Subject: Responses to Request for Additional Information on WCAP-12472-P-A Addendum 2,  
"BEACON Core Monitoring and Operation Support System"

Reference: (1) Letter from S. D. Bloom (NRC) to H. A. Sepp (Westinghouse), Request for  
Additional Information for Westinghouse Topical Report WCAP-12472-P-A,  
Addendum 2, "BEACON Core Monitoring and Operation Support System",  
(TAC No. MB1711) July 11, 2001

REQUEST FOR ADDITIONAL INFORMATION ON WCAP-12472, ADDENDUM 2,  
BEACON CORE MONITORING AND OPERATION SUPPORT SYSTEM

## OPARSSEL SELF-POWERED NEUTRON DETECTOR GENERAL ARRANGEMENT

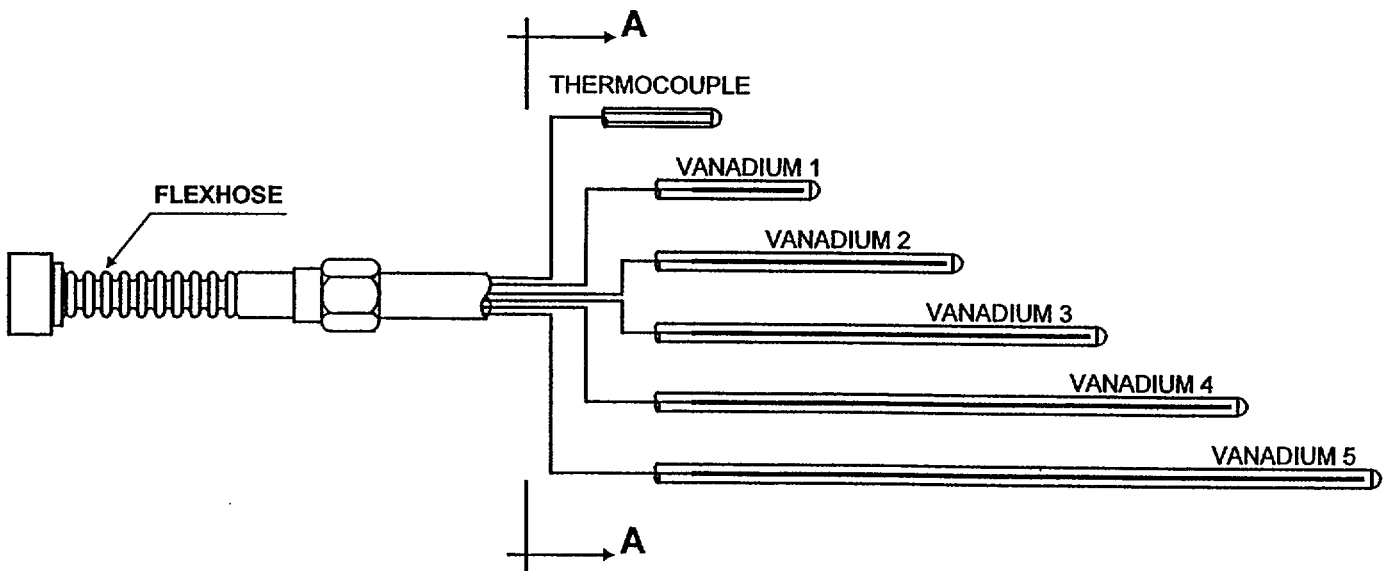
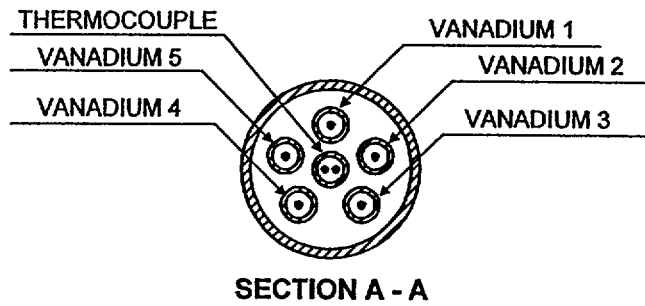
3. Figure Four shows that the Platinum detectors are arranged with four detectors in a string. It is not clear from Figure Five how the Vanadium detectors are arranged.

**Response:** The detectors are as illustrated in Figure 5 of Addendum 2. The detectors are of unequal lengths. The first detector is a full-length detector covering the entire core. The second detector is 80% of full length; the third detector is 60%, and so on. Individual axial segment measurements are obtained by subtracting the currents of each successive detector. This configuration has several benefits for fixed incore detectors. First, since the vanadium current is lower than Rhodium, this longer detector configuration gives a stronger signal. Because there is no exposed lead wires in this configuration, no background wire is required, meaning no manipulation of background data is required. Finally because no background wire is used, the connector for the background wire can be used to add an additional detector. Therefore a plant that had only 4 Rhodium detectors in a string can increase the number of detectors to 5 with the Vanadium design, thus improving the axial resolution of the measurement.

A more detailed picture is shown below.

Note that in Addendum 2, we show the vanadium detectors arranged in this overlapping OPARSSEL arrangement and the Platinum arranged in the more traditional equal length arrangement. The BEACON methodology is not limited to these configurations of detector and material. BEACON can address any number of detectors in a string and any configuration of detector material.
